Appendix 5: Pre-hearing meeting notes

IN THE MATTER OF: A private plan change request by Oakura Farm Park Ltd to change the Operative District Plan to enable future development at land situated at 156 Upper Wairau Road and 1215-1277 South Road, State Highway 45, Oakura.

**PRE-HEARING REPORT PURSUANT TO SCHEDULE 1 CLAUSE 8AA (5) OF
THE RESOURCE MANAGEMENT ACT 1991**

DRAWING
EQ-01

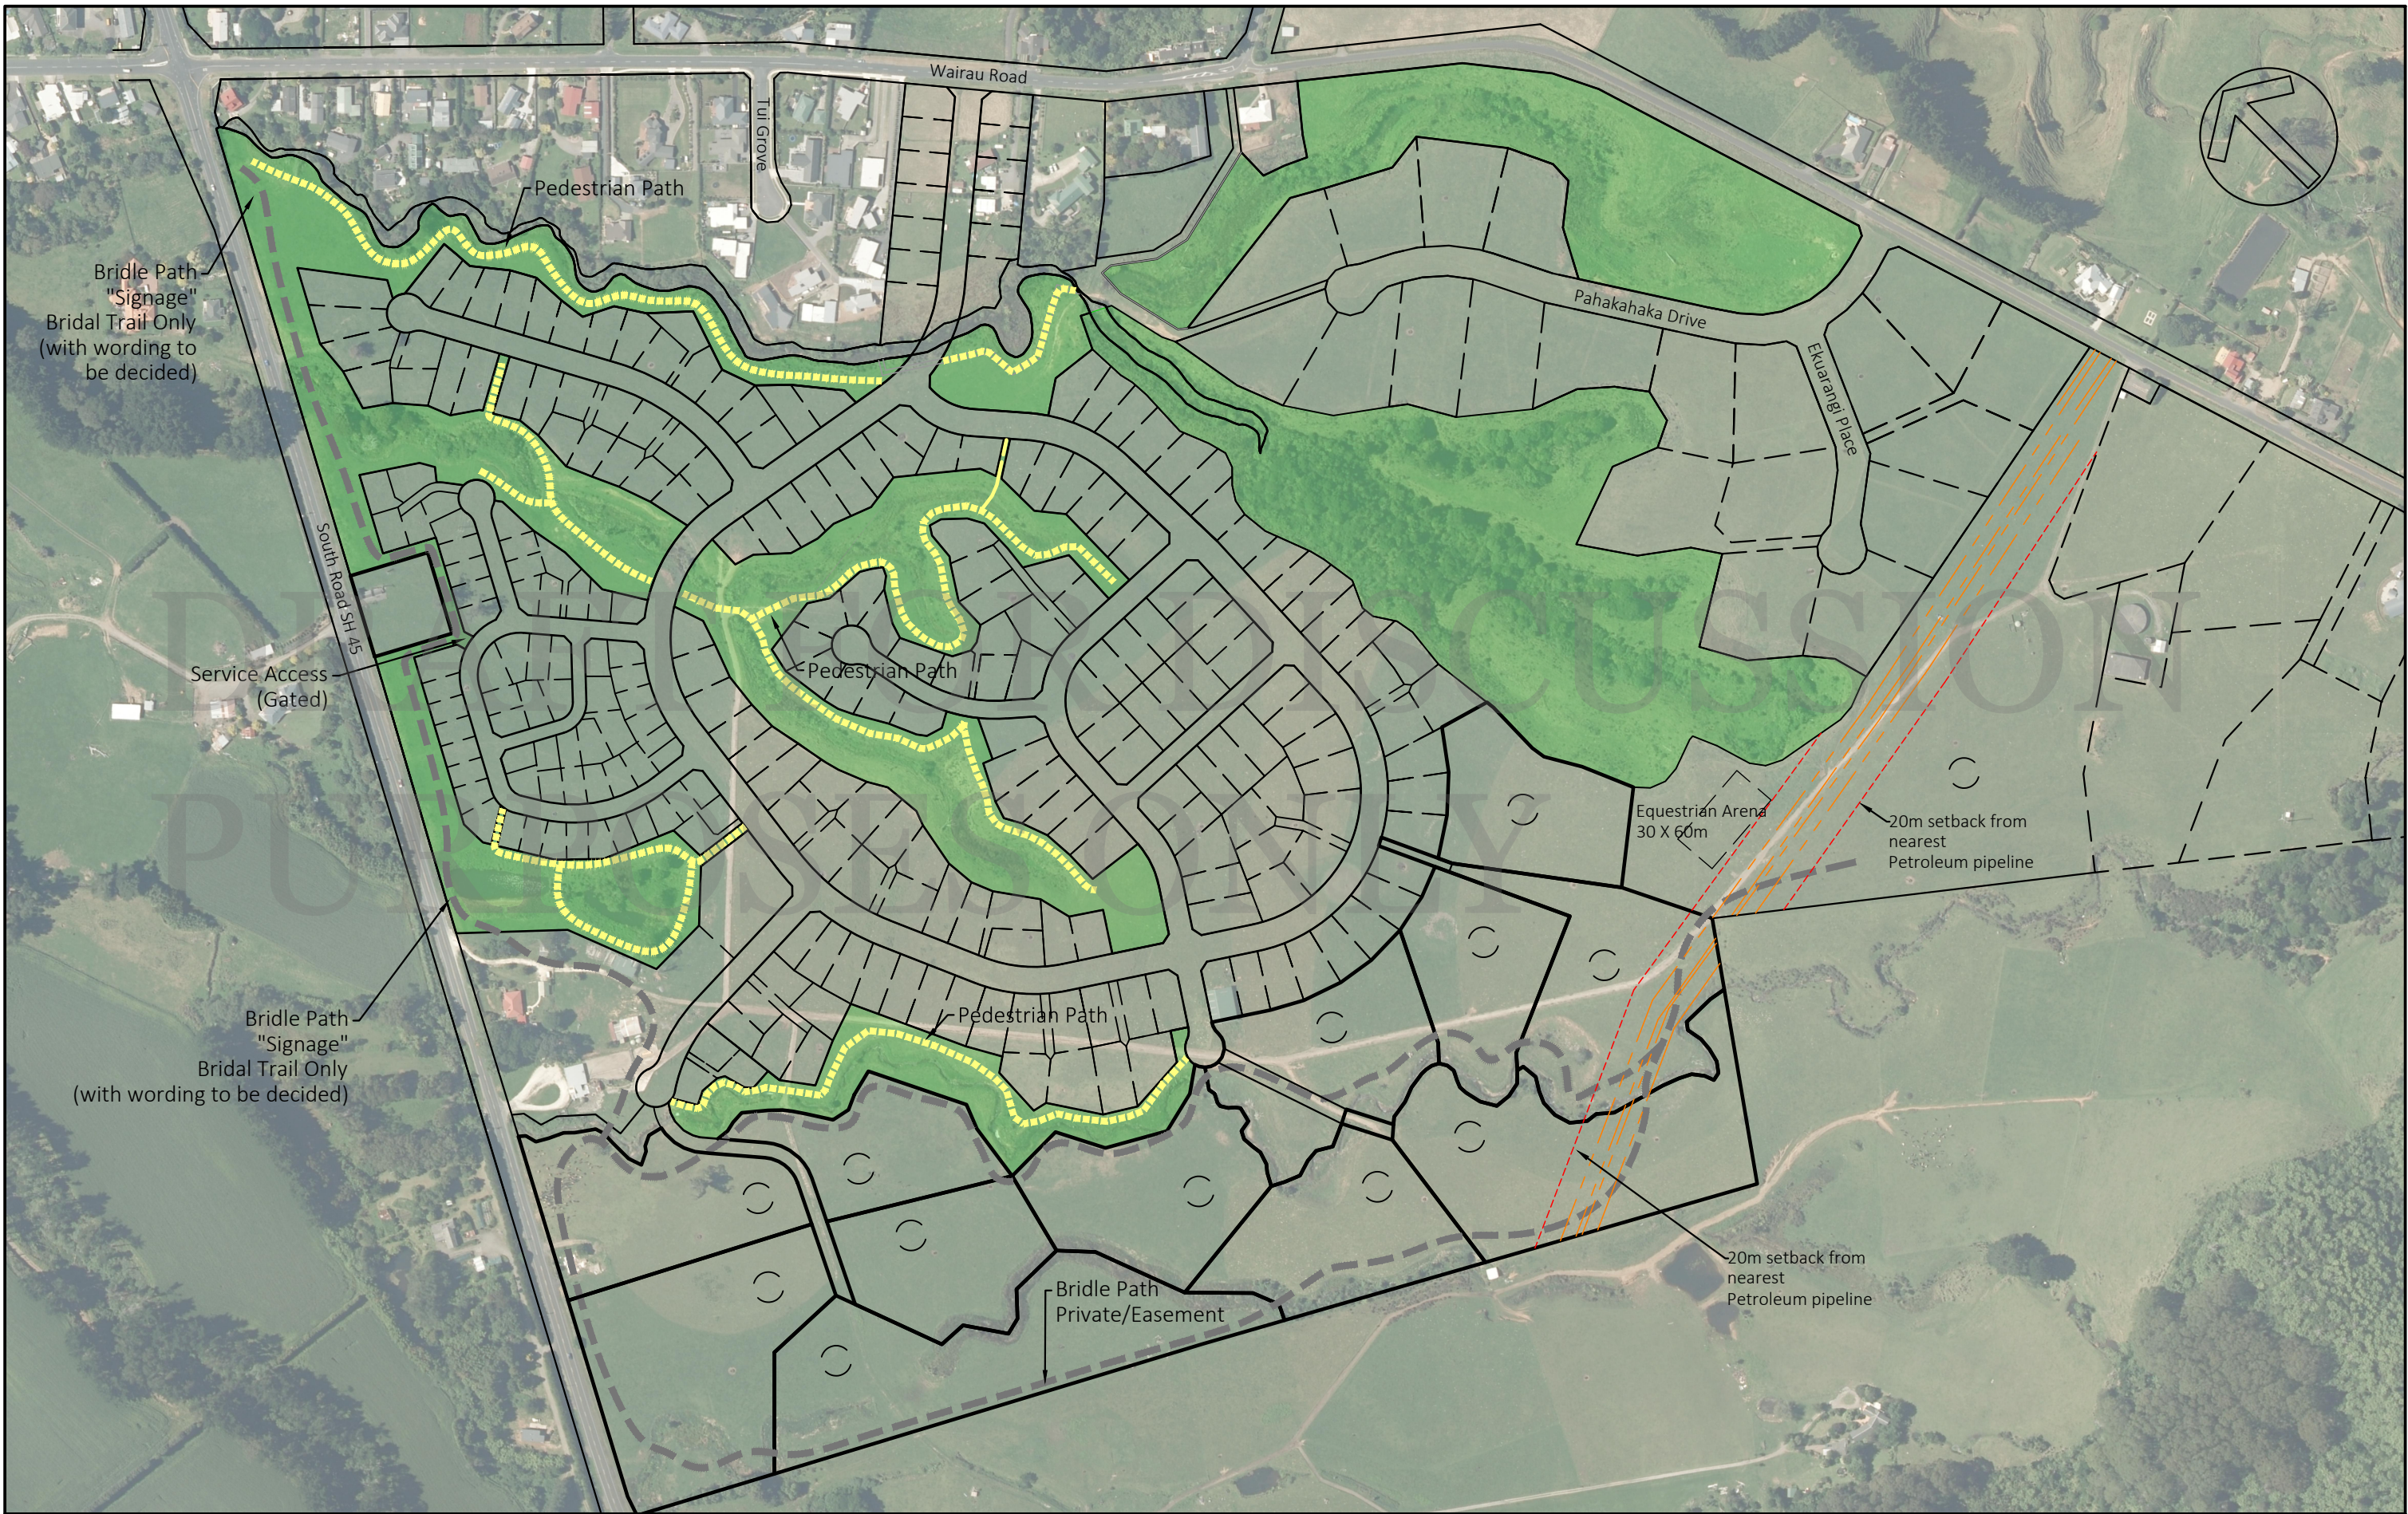
15. The applicant accepted that there needed to be a dedicated equestrian route within the development. The applicant tabled a plan (Ref: McKinlay EQ-01) showing a proposed equestrian-only bridle track. The applicant identified and explained their suggested Bridle track (with new reserves) which will be parallel with SH 45 and will go around the Powerco site. The trail would then head out to the SH45/Wairau Road intersection and then connect with the proposed underpass. The applicant stated that the proposed underpass could connect with a future esplanade reserve/strip (shown on District Plan Map A61) heading down the valley to Messenger Tce and onto the beach.

16. TEN agreed with the applicant's suggested bridle path and noted that they had the same idea as the applicant and that they were pleased with the safe access off Wairau Road. The applicant suggested that the proposed track would provide a safe margin between SH45 and the toe of the noise bund. TEN noted that this was an excellent solution.

19. TEN and the applicant agreed on the proposed bridle track and that the only detail that was required pre-hearing or at the hearing was that the bridle track would be added to the Structure Plan.

- That the applicant's suggested bridle path on the site was an effective means of providing for equestrian access throughout the site.
- The applicant to confirm amendment to Structure Plan showing bridle trail along State Highway 45 frontage/open space area.

DRAWING
 C-09

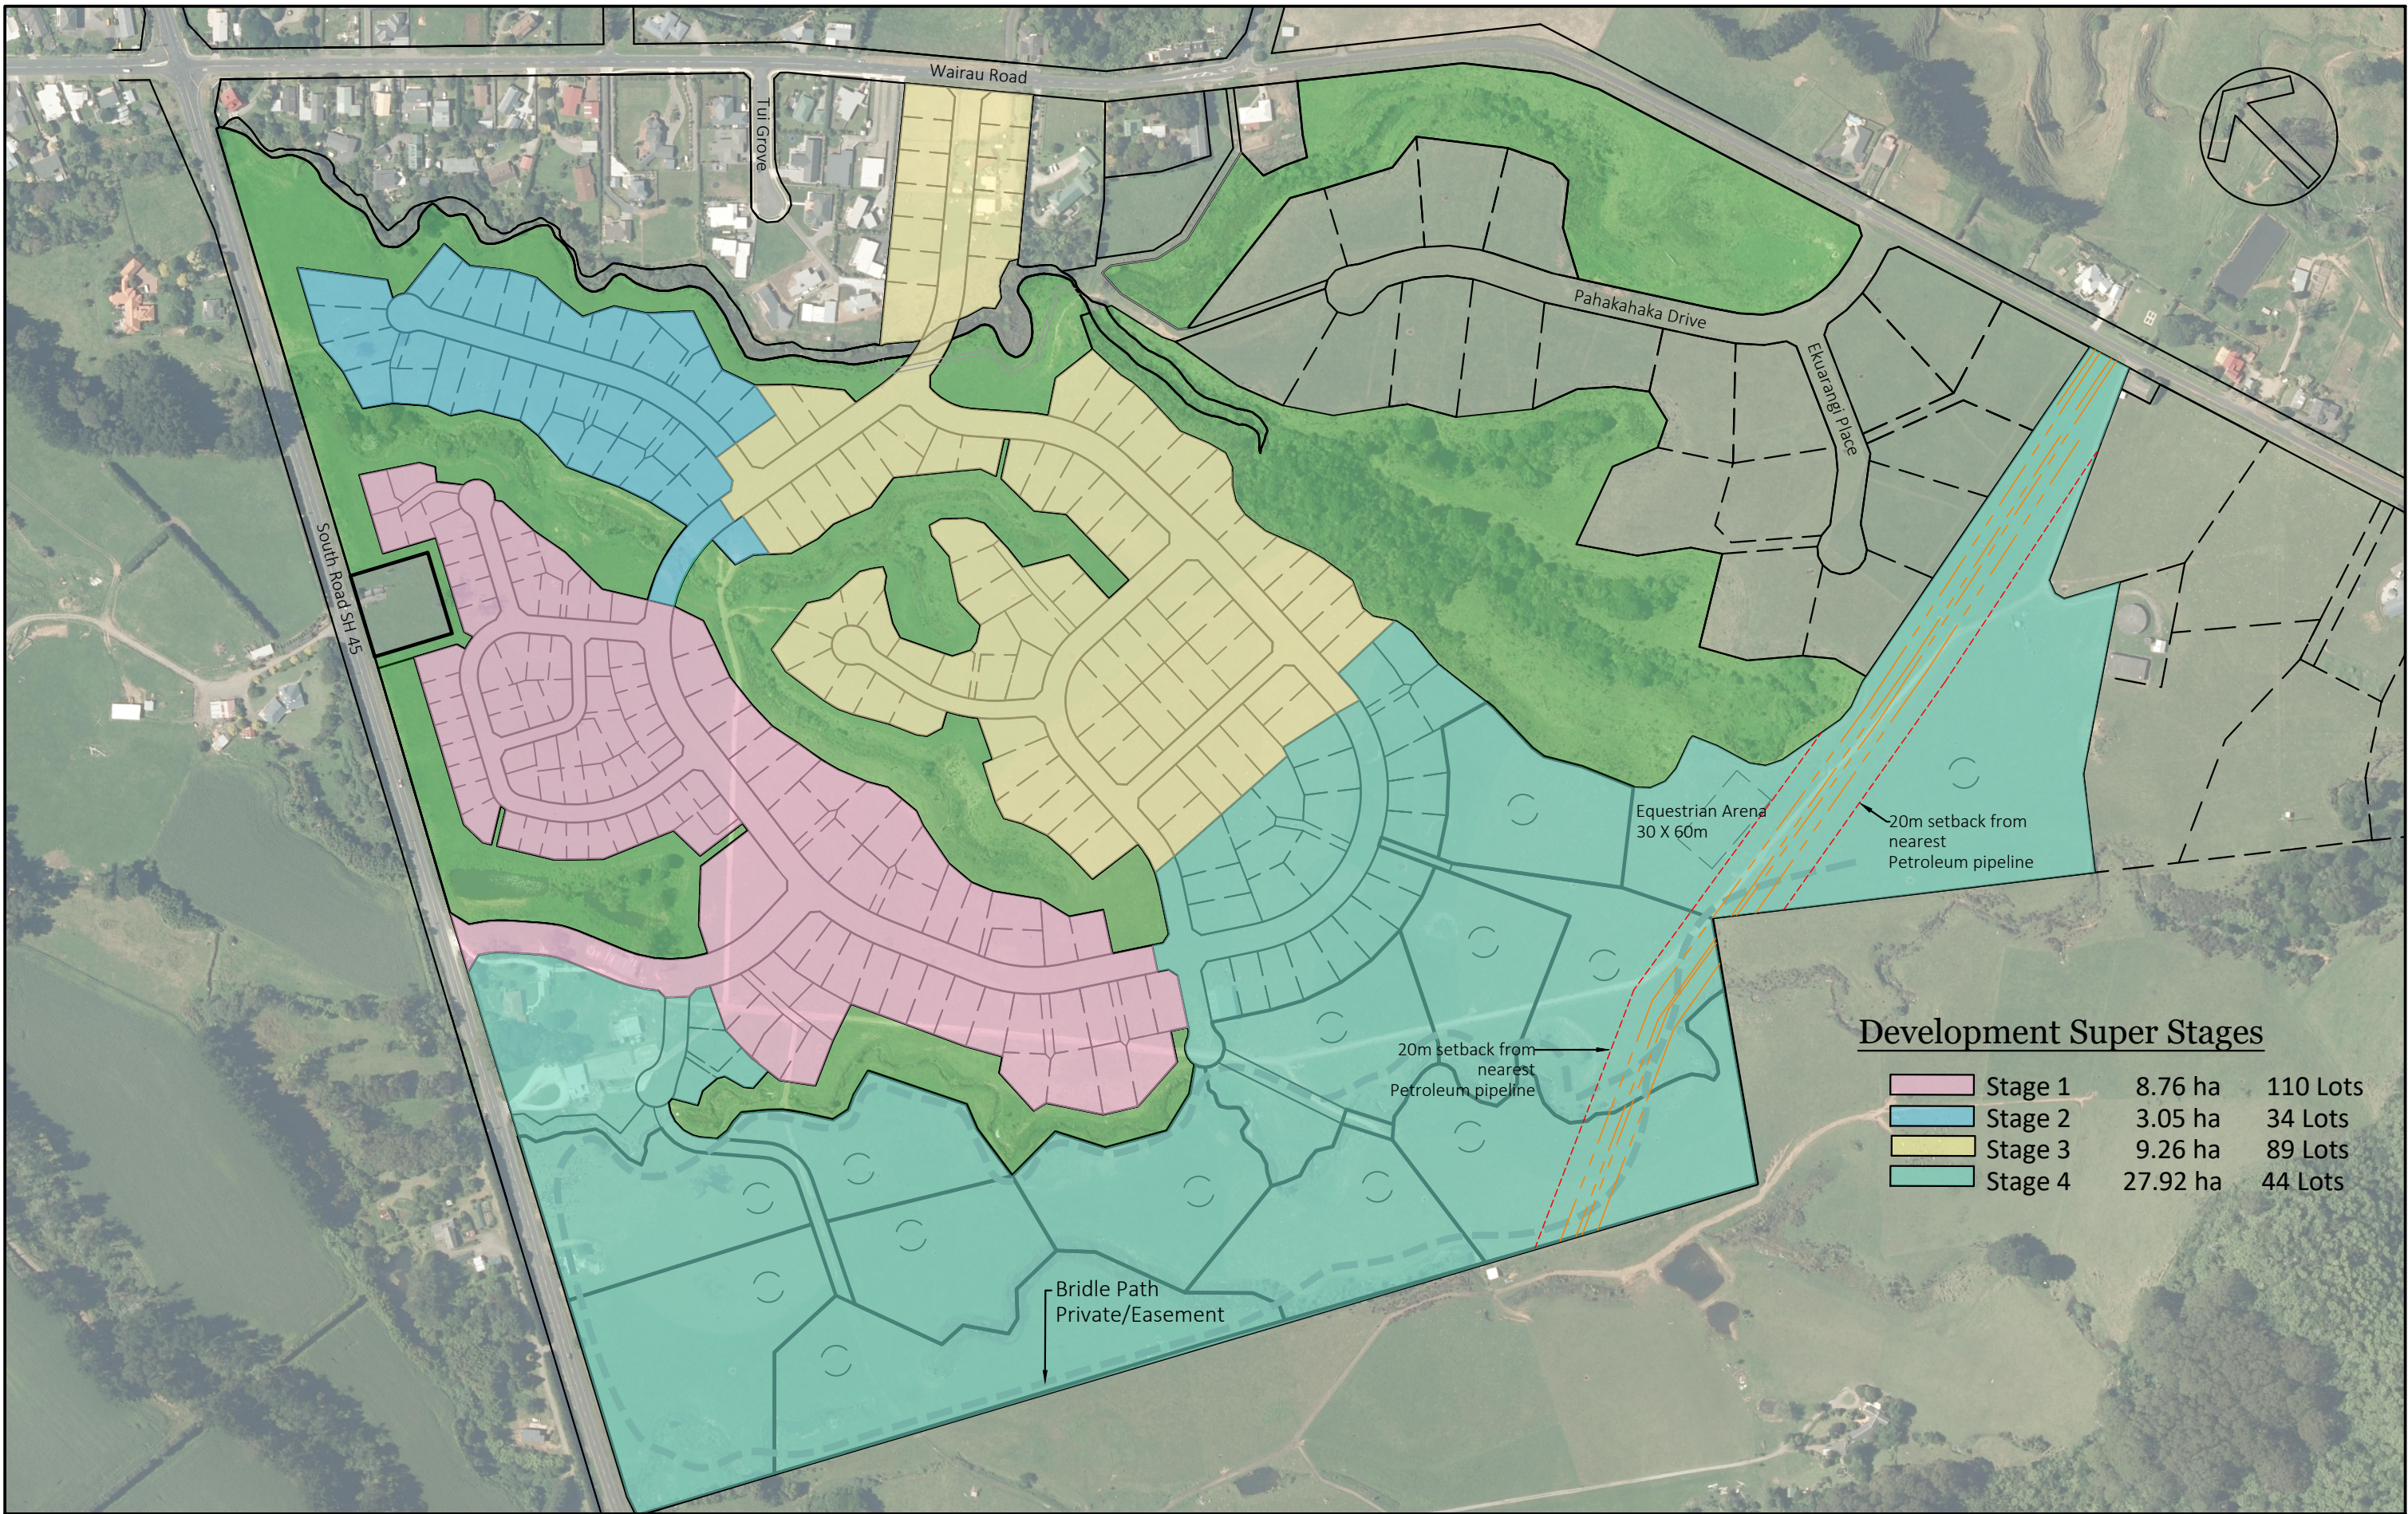
17. The applicant advised that they had been reviewing submissions and considering how the development could be staged. The applicant tabled new super staging plans (C09 and C10) for discussion with submitters and NPDC. An option the applicant is considering to manage growth is that Stage 1 and Stage 2 (a combined area of approx 12ha) proceed first, and any further stages will not proceed until the underpass and roundabout are constructed. It was acknowledged that that growth will be incremental whereby after 75% of the 12 hectares is committed/ purchased then only additional stages will proceed.

- Applicant: To confirm whether it is proposing a new/alternative staging plan, including whether plan provisions are proposed to link development of stages with provision of infrastructure (i.e. new roundabout and underpass on SH45). In addition, provide confirmation as to whether alternative roading patterns are available or proposed, such as new/alternative access via SH45.
